Control sheet for Standard Engineering Details 0612, 0613, 0614, 0617 and 0626

12 August 2009:

Revisions to standard engineering details as follows:

CONCRETE VEHICLE CROSSING RESIDENTIAL

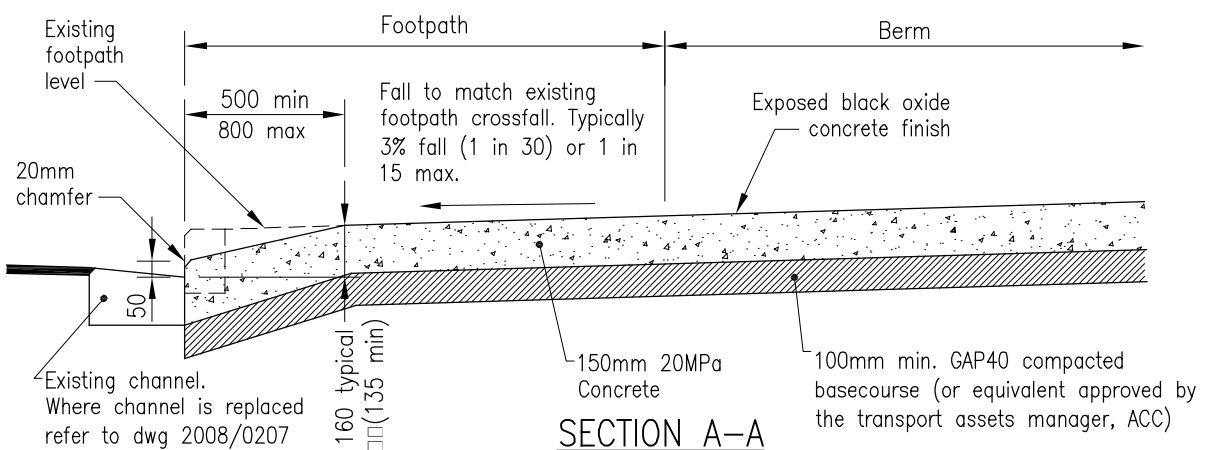
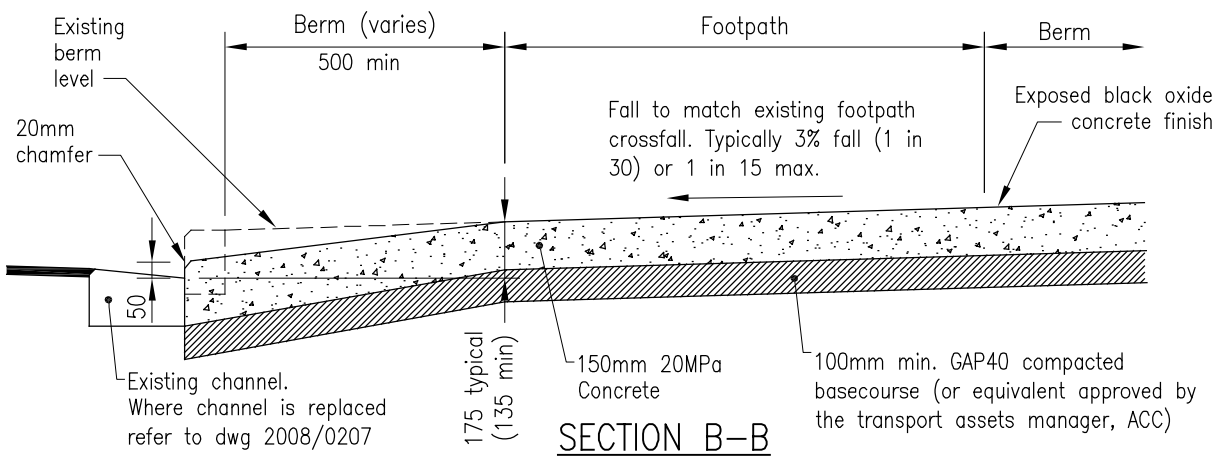
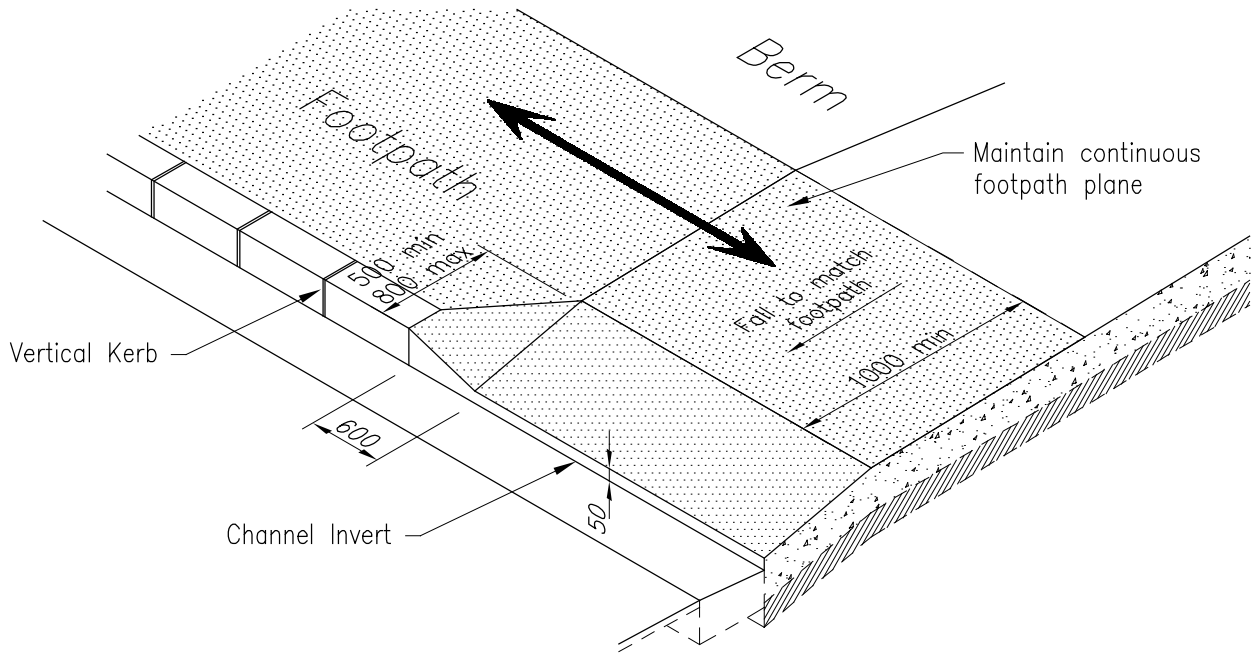
- Increased height of the 'lip' from 20mm to 50mm.
- Removal of the radial block.
- The taper of the splay at the entrance of the vehicle crossing has been standardised to 600mm on each side.
- For vehicle crossing next to the kerb - the ramp depth has been specified to be a minimum of 500mm and a maximum of 800mm to provide for a 1 meter wide continuous footpath plane for pedestrians. Fall to match the full width of the footpath.
- The width of the vehicle crossing at the boundary and at the kerb side has been corrected to reflect a single vehicle entrance i.e 6000 max width dimension has been removed.
